**HOLD HEARING FOR VACATION OF A FEE INTEREST AND SUBSURFACE RIGHTS
IN PORTIONS OF WATSON POWELL JR. WAY STREET RIGHT-OF-WAY AND THE
ADJACENT NORTH/SOUTH ALLEY RIGHT-OF-WAY ALL ADJOINING 550 WATSON
POWELL JR. WAY AND CONVEYANCE OF A FEE INTEREST AND AN EASEMENT
FOR SUBSURFACE BUILDING ENCROACHMENT THEREIN TO HRC 6TH STREET,
L.L.C. FOR \$34,308.00**

RE: 550 Watson Powell Jr. Parkway, Carbon 550

We have reviewed the first (1st) submittal of the site plan for the Carbon 550 project, located at 550 Watson Powell Jr. Parkway in Des Moines, and have determined that the following conditions must be satisfied before plan approval can be granted.

DESIGNER: CIVIL DESIGN ADVANTAGE
 DATE: 11/15/16
 PROJECT: CARBON 550
 SHEET: C2.1

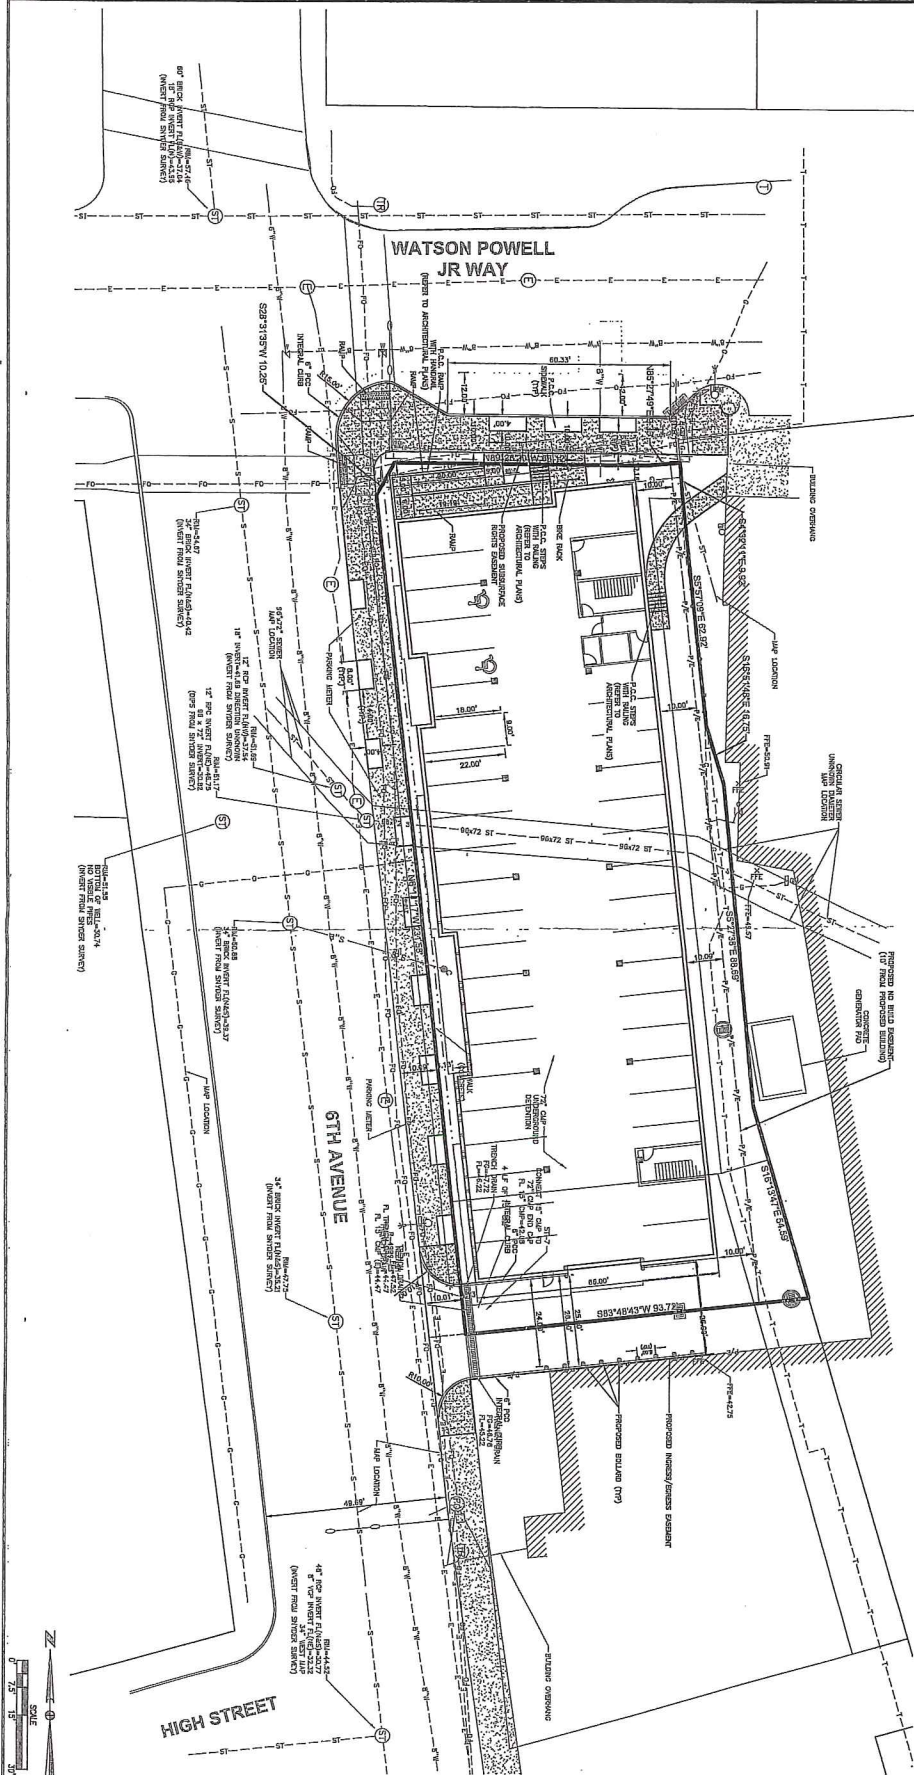
1. We prefer drawings to utilize a common engineering scale such as 1" = 20 feet.
2. On sheet C2.1, a number of the dimensions that detail information along the sidewalks of Watson Powell and 6th Avenue are obscured by various lines, text and patterns. Please review and correct.

C3.1 1604.218	CARBON 550 GRADING PLAN	 CIVIL DESIGN ADVANTAGE, INC. DES MOINES, IOWA	3405 S.E. CROSSROADS DRIVE, SUITE G GRIMES, IOWA 50111 PHONE: (515) 389-4400 FAX: (515) 389-4410		REVISIONS	DATE
			ENGINEER:RAH	DRAFTED:RAH		
						11/09/11

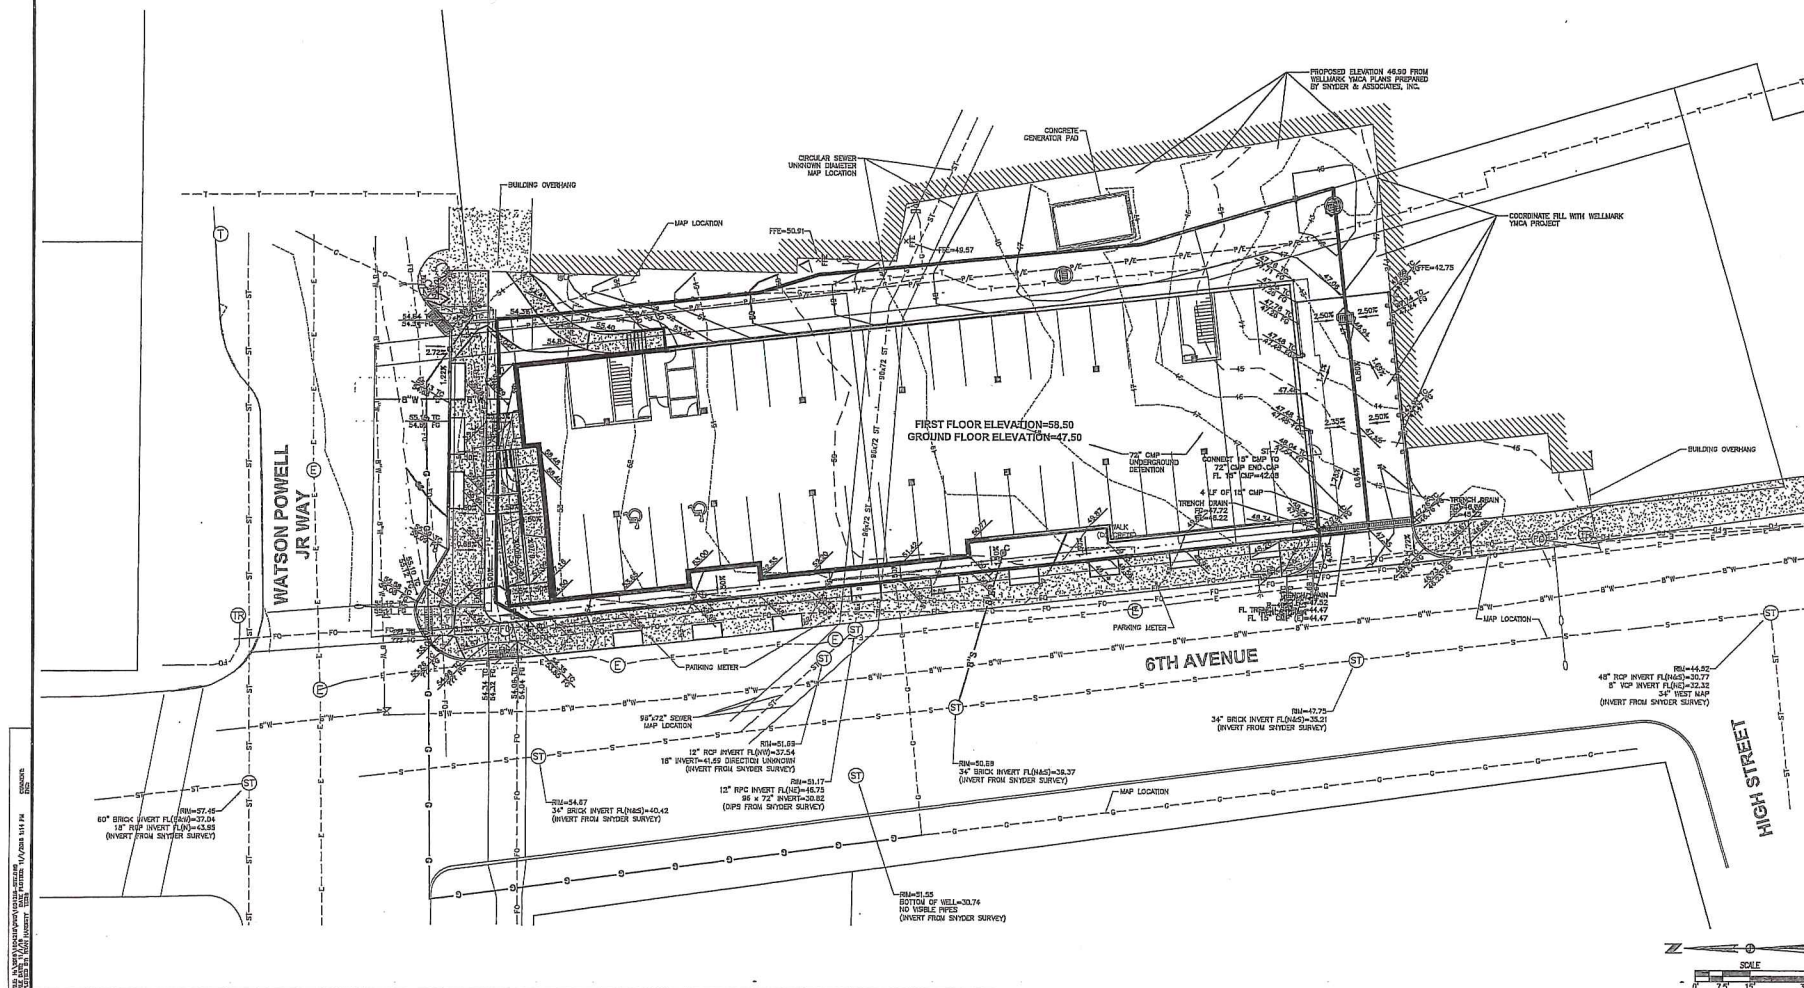
3. The parking area is to be drained to the sanitary sewer with proper oil and sediment traps as per the UPC. Sheet C4.1 should address this requirement.

PROJECT: CARBON 550 LANDSCAPE PLAN

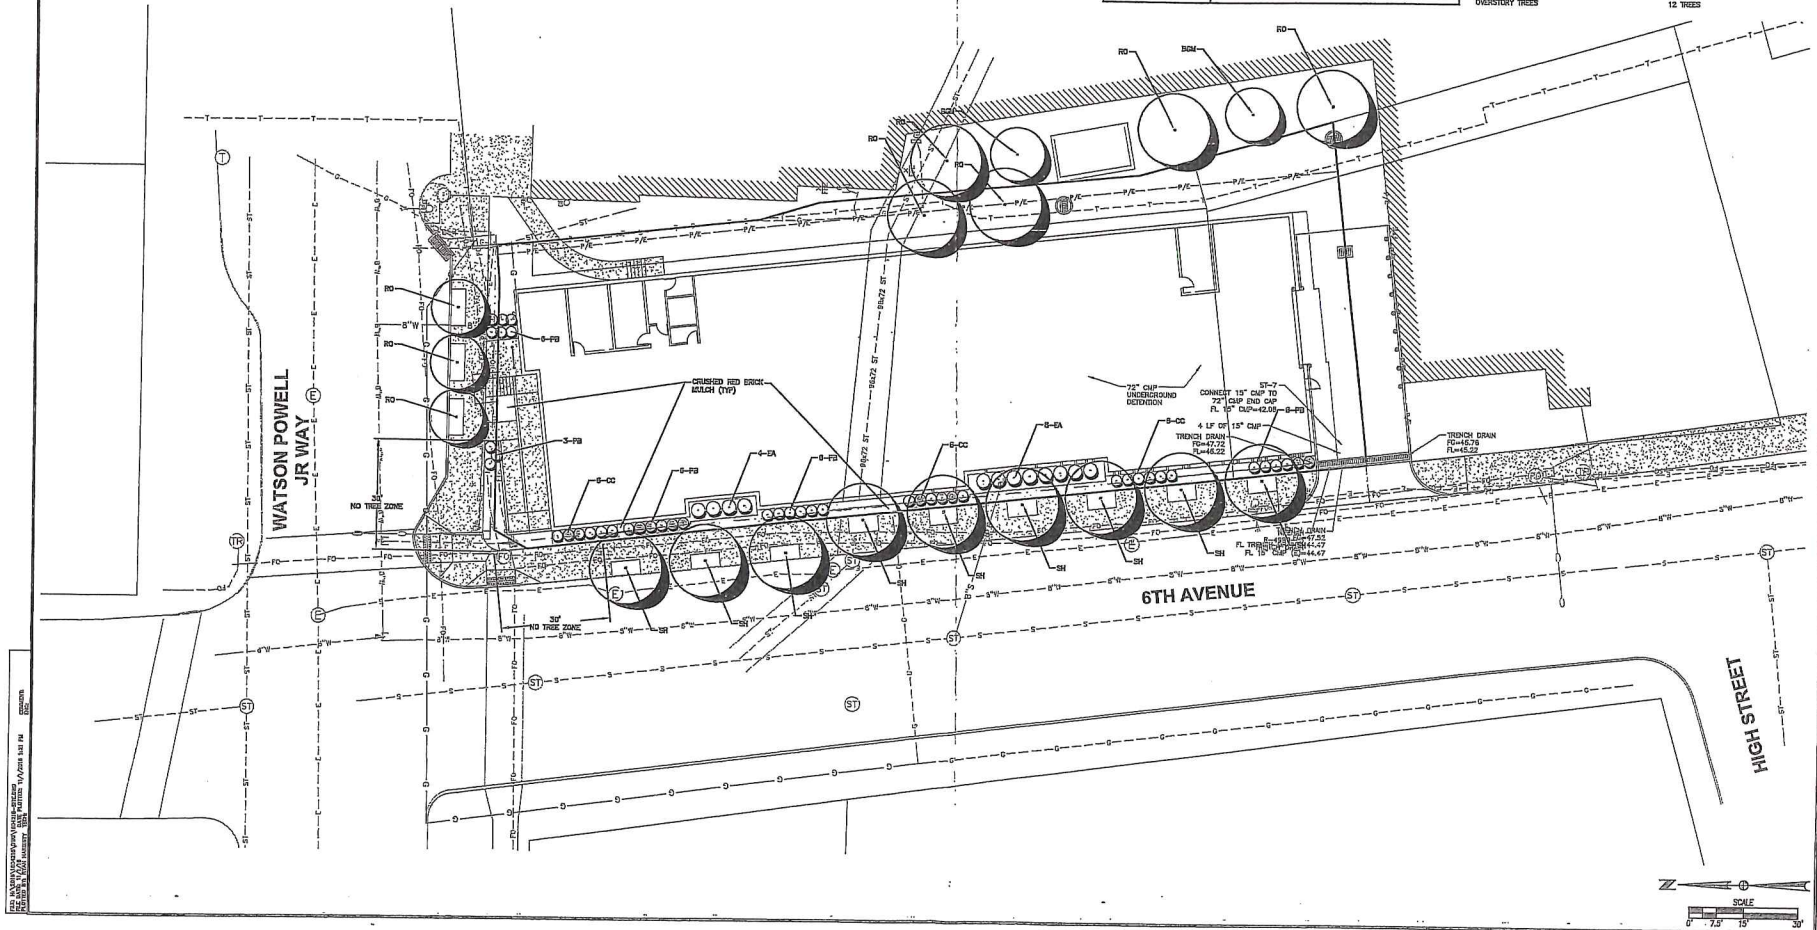
23. Note and show the dimensional width of the sidewalk widths and associated tree planters / landscape planters. This should include the planter width and depth dimensions as well as distance from curb and to property line. Typical planter dimensions are a 5' X 15' planter, 1' back of curb, with a 6' walk. The proposed planters along both street frontages are not consist with this requirement and will require significant alterations. The deviation from this requirement appears to be due to utilities located within the right-of-way, however our Municipal Arborist has indicated that planting per our typical requirement shall be upheld.

Trees on center must not be any closer than 15' to a light pole which it appears as though the planter closest to the drive, furthest south, on 6th Avenue is in conflict with this requirement. A new lighting plan should be submitted for approval that takes into consideration the maximum number of plantings possible and the appropriate spaces with lighting coverage per City Ordinance.

24. Provide a parkway planting illustration and note the growing conditions or soil amendment to be provided on the site plan. Add the following notes relative to the illustration:
